ECE/TRANS/WP.15/AC.2/32/Add.1
9 October 2009

**REPORT OF THE JOINT MEETING OF EXPERTS ON THE REGULATIONS
ANNEXED TO THE EUROPEAN AGREEMENT CONCERNING THE
INTERNATIONAL CARRIAGE OF DANGEROUS GOODS BY INLAND
WATERWAYS (ADN SAFETY COMMITTEE) ON ITS FIFTEENTH SESSION***

Addendum

PROPOSED AMENDMENTS TO THE REGULATIONS ANNEXED TO THE ADN
ADOPTED BY THE SAFETY COMMITTEE
FOR ENTRY INTO FORCE ON 1 JANUARY 2011

"Figure 2.4.3.1: Categories for substances long-term hazardous to the aquatic environment"

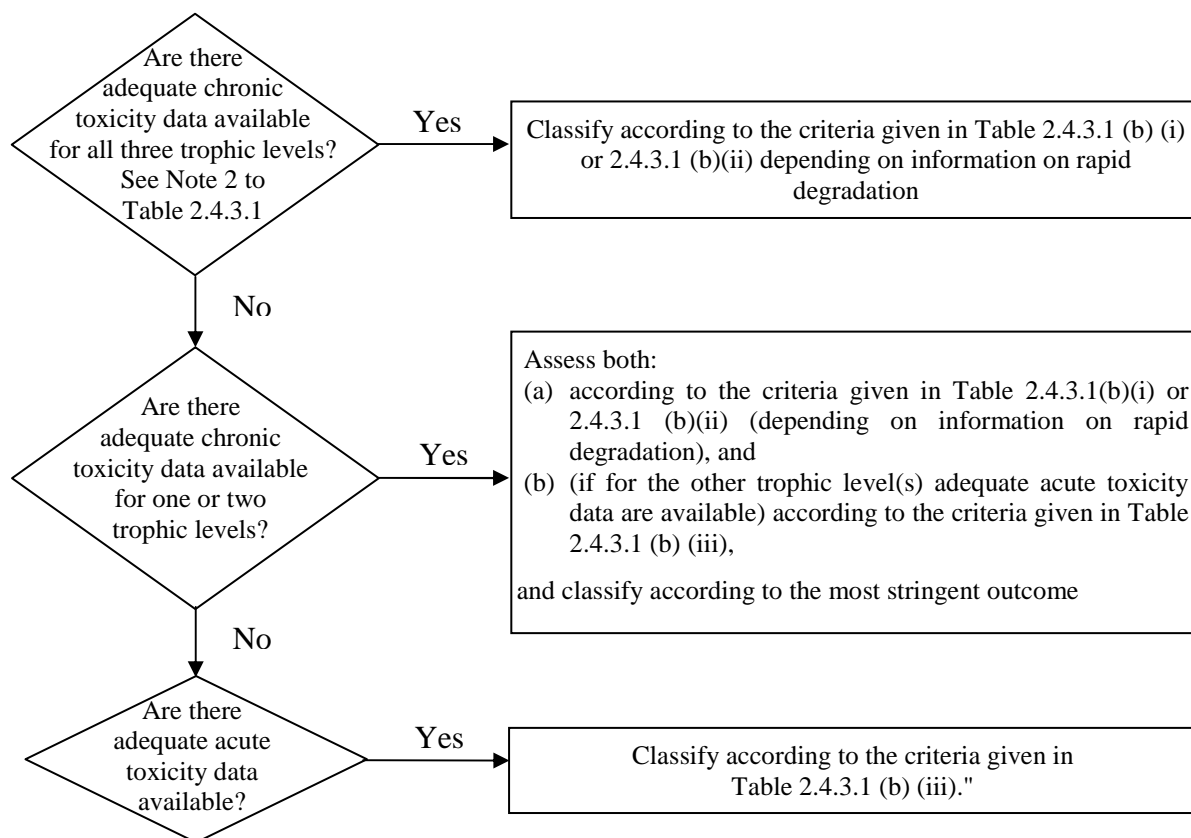
2.4.3.1 Add the following figure:
